Preservation Department – Item 1, LPC-22-04647

**105-107 Bank Street – Greenwich Village Historic District
Borough of Manhattan**

NYC Landmarks Preservation Commission

SEPTEMBER 13, 2022

PREVIOUS AND PROPOSED PENTHOUSE COMPARISON

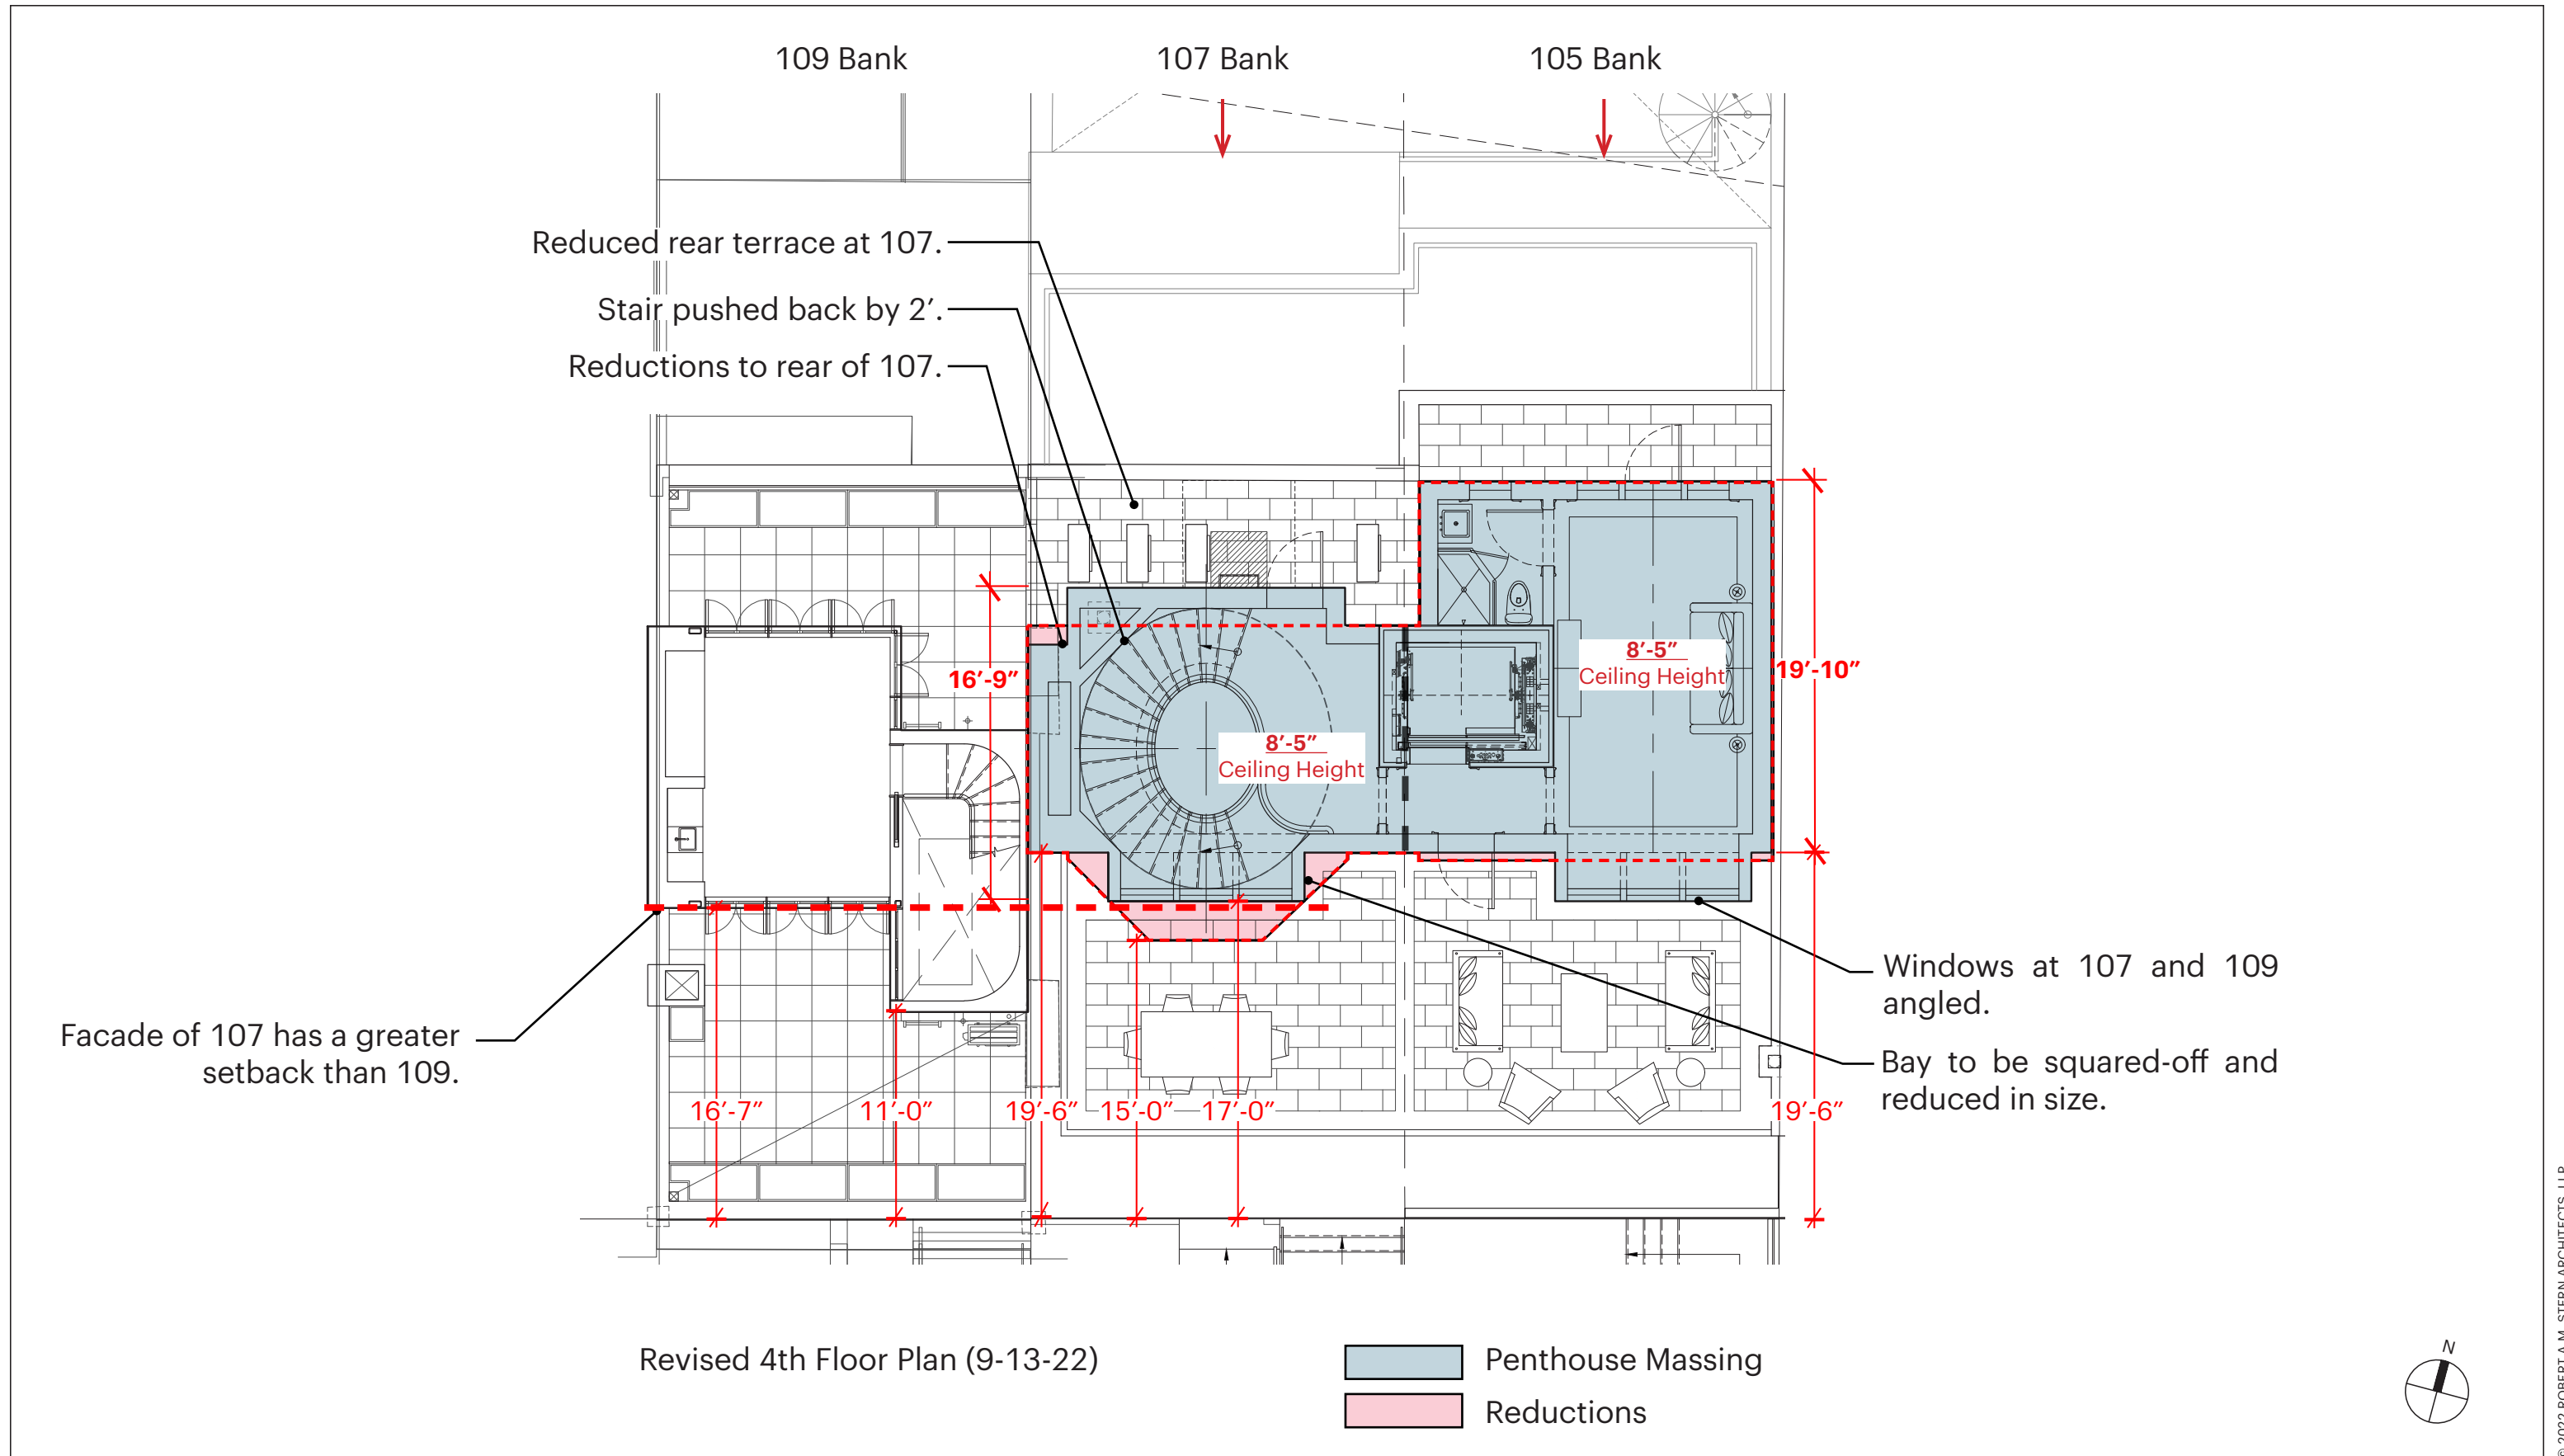
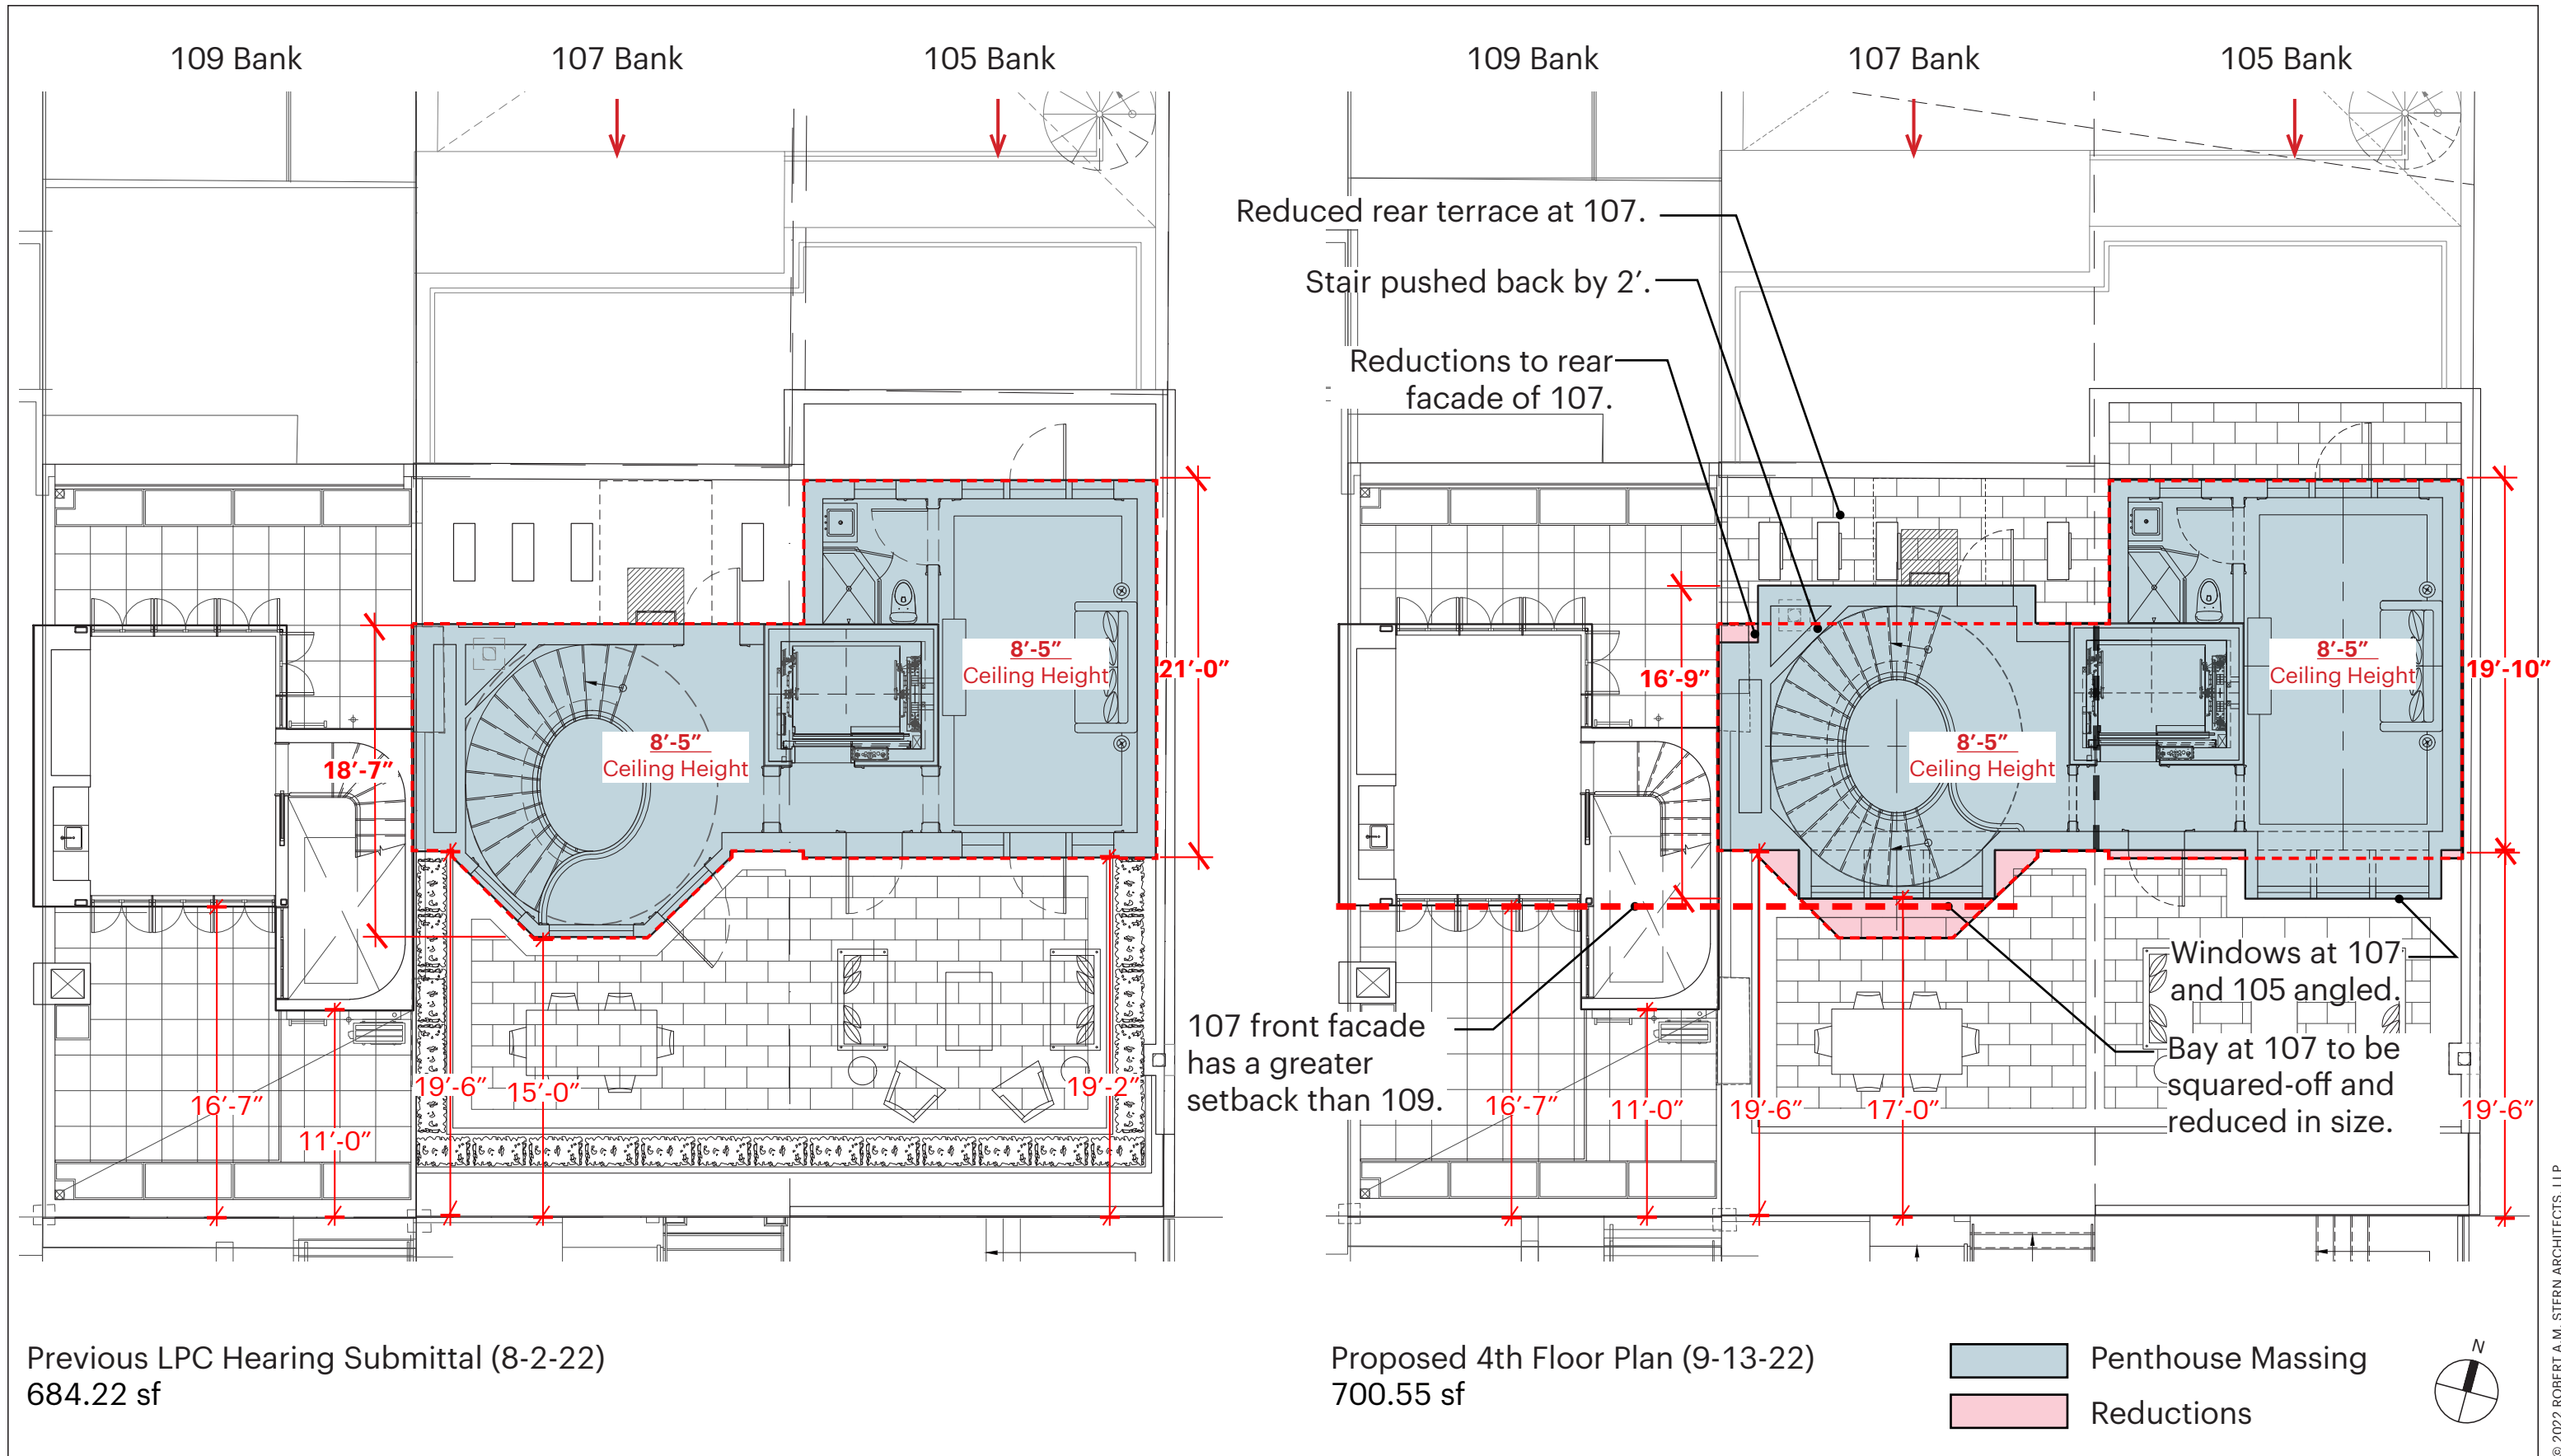
- 1. Reconsider the form or materiality of the octagon bay window to make it less eye catching.**
- 2. Further reduce and simplify the visibility of rooftop addition.**

Penthouse Massing
 Reductions

PENTHOUSE ELEVATION COMPARISON

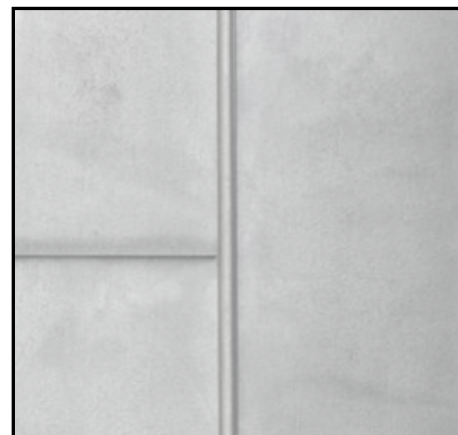
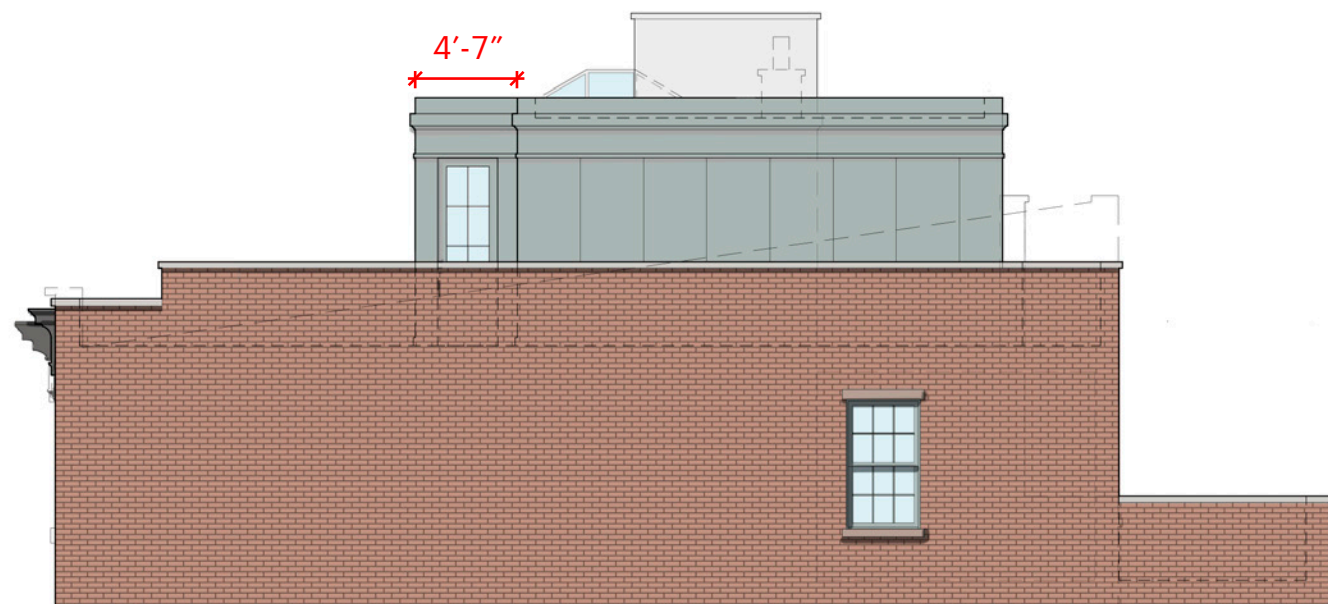
“Three major areas that we have asked you to study have been responded to successfully and it is just thinking about the visibility of the rooftop additions and looking at changes to both or one of them, particularly looking at that octagon bay window which I think is calling attention to the addition.

Bays at 107 and 105 to be angled back, squared-off and reduced in size to minimize visibility. Reduced window frame and increased glazing.

Horizontal gutter on both bays.

1. Penthouse and Bay Addition
Material: Copper
Color/Finish: Pre-patinated Copper

2. Penthouse Material: Zinc
Color/Finish: Gray

PROPOSED PENTHOUSE SIDE ELEVATION

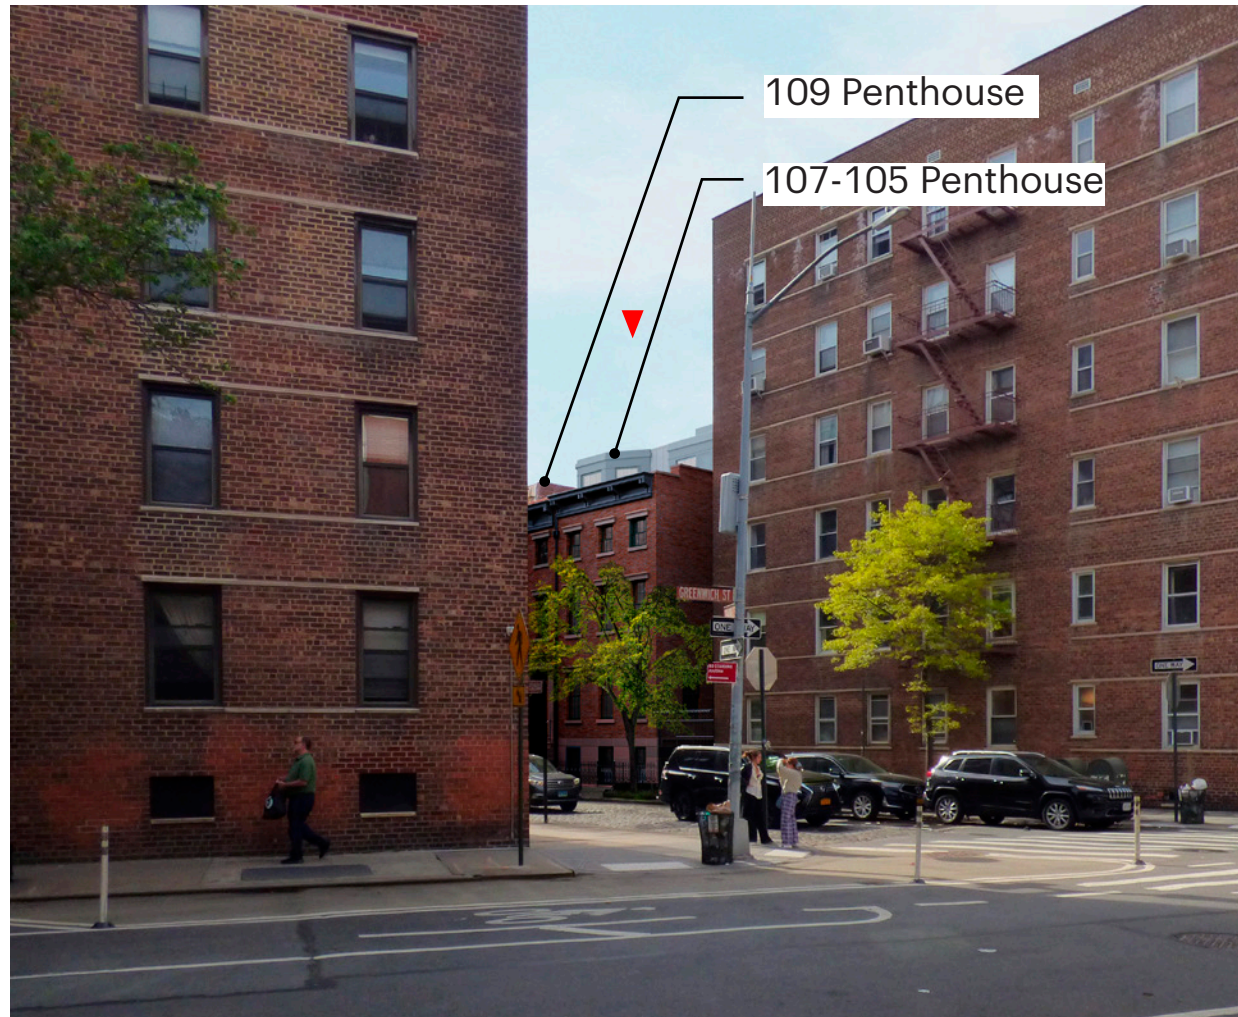
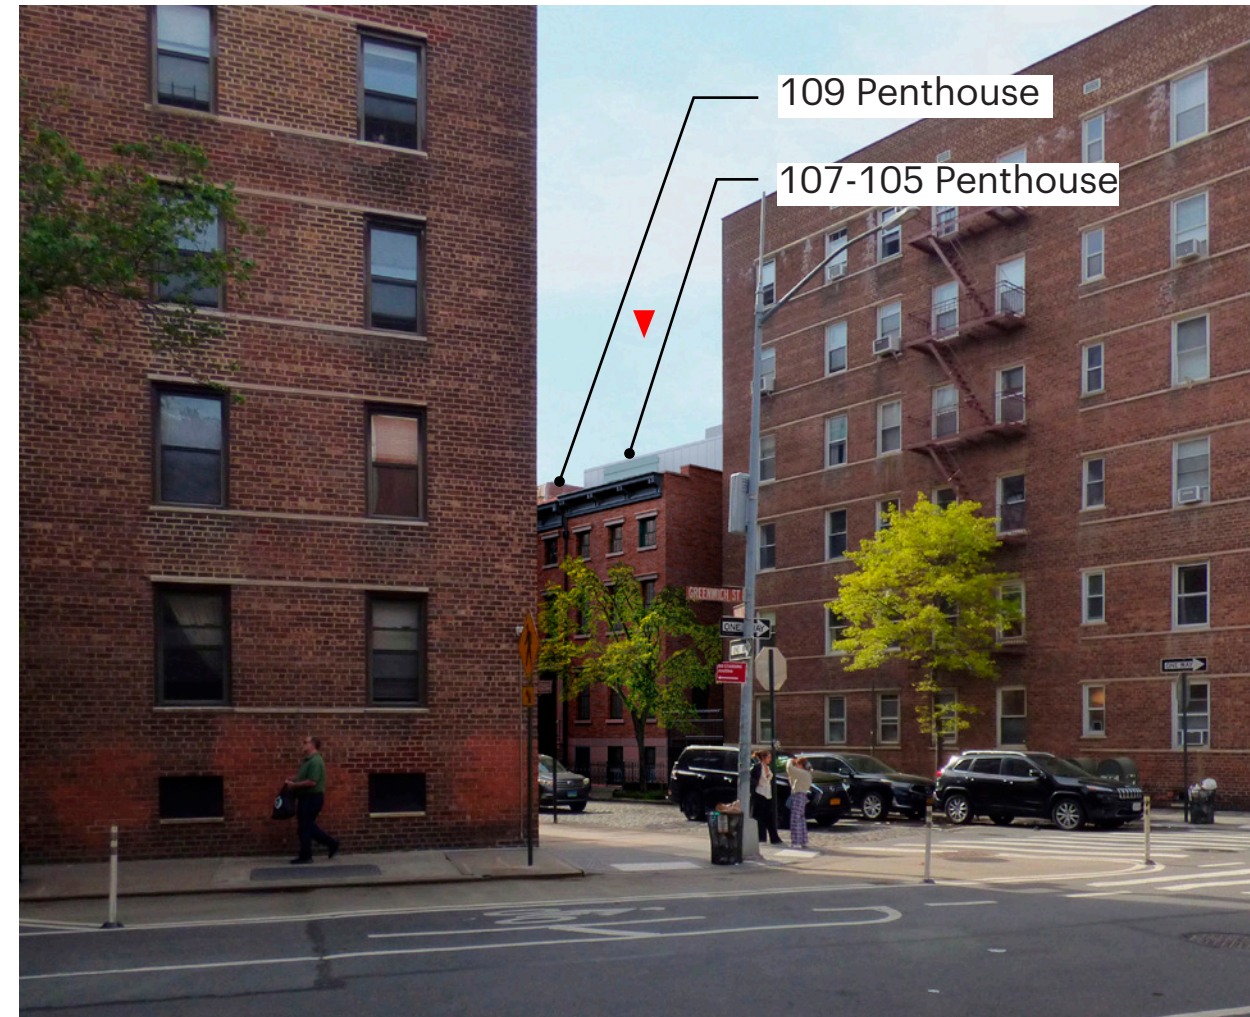
I will ask you to think about how you can further reduce and simplify the visibility of rooftop addition. And we will leave it up to you to figure out how: setting back further, changing shape or material just to make it more neutral and less attention catching.”

Zinc material to wrap around side elevation
